August 2, 2019

This letter is an objection, pursuant to 36 CFR §218, to the Lost Creek-Boulder Creek Landscape Restoration project, on behalf of the Alliance for the Wild Rockies, Idaho Sporting Congress and Native Ecosystems Council (collectively, “AWR”). The Responsible Official is Payette National Forest Supervisor Keith Lannom. The Lost Creek-Boulder Creek Landscape Restoration project is planned for the New Meadows Ranger District of the Payette National Forest (PNF).

NOTICE IS HEREBY GIVEN that AWR objects pursuant to 36 CFR §218 to the Responsible Official’s adoption of Alternative B- modified (“further referred to as the Selected Alternative” – draft ROD at 3).

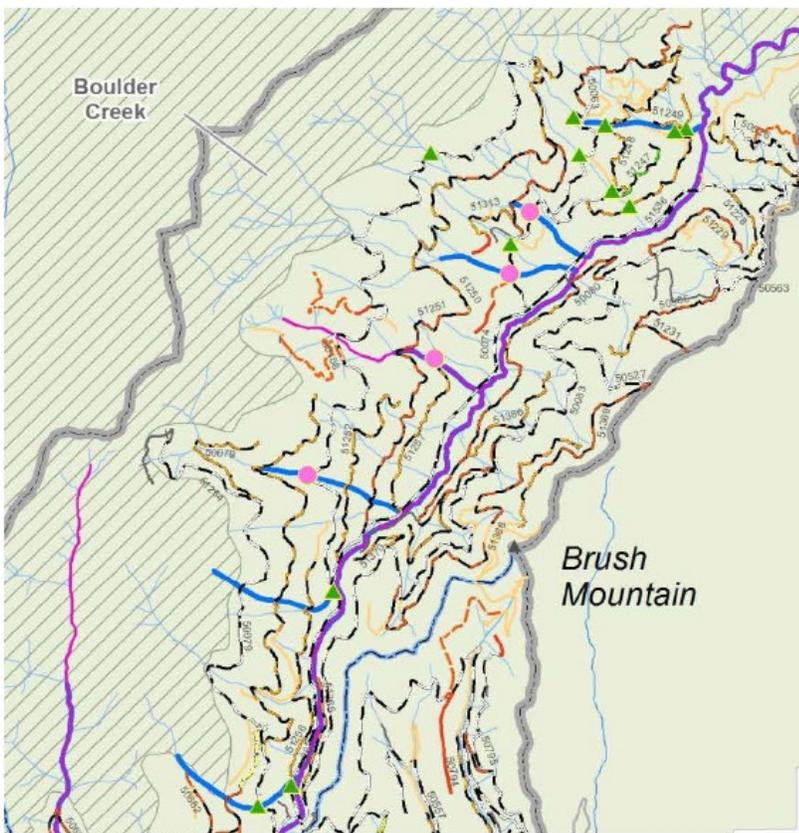
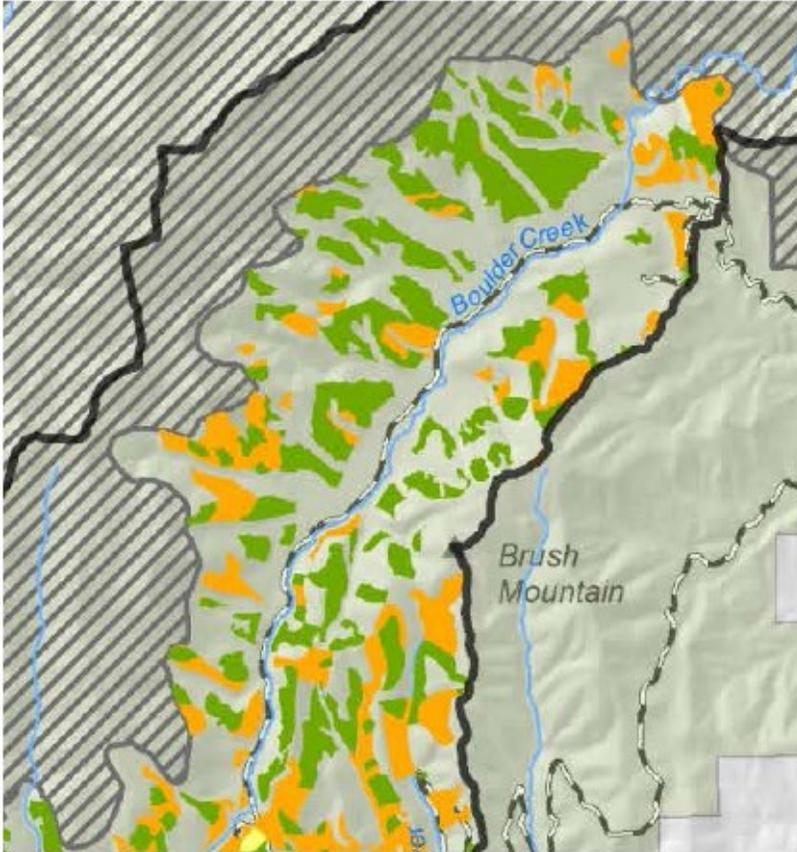
(Appendices – 83, emphasis added.) We don’t find a section in the FEIS entitled “Roadless Area Analysis and Analysis of Unroaded Lands Contiguous to Roadless Areas.” Instead, FEIS section 1.13.6. is entitled simply “Inventoried Roadless Areas.” Clearly the FEIS completely ignored AWR’s comment specific to unroaded areas adjacent to the IRA, and in regards to impacts on roadless areas generally. Since the FEIS presents no analysis whatsoever on this issue, the figure below and on the following page help to display our concerns.

In comparing the above two figures (portions of maps found in the FEIS map packet), we're assume that the first one shows all system roads. The second shows logging units colored green and yellow. Both show Inventoried Roadless Areas in diagonal lines. It is not difficult to see that areas immediately adjacent to the IRA—not separated from it by any road or other discernable management feature—would be logged. There is plenty of federal court precedent supporting AWR in the type of analysis our DEIS comments requested. As it stands, the PNF is proposing an irretrievable commitment of unroaded lands preventing them from being considered for Wilderness designation, without any analysis and disclosure required by NEPA.

REMEDY: Prepare a Supplemental Draft EIS analyzing and disclosing the impacts on unroaded areas and on the integrated IRA/unroaded as a whole, also considering the best scientific information on the importance of roadless areas for ecological integrity.
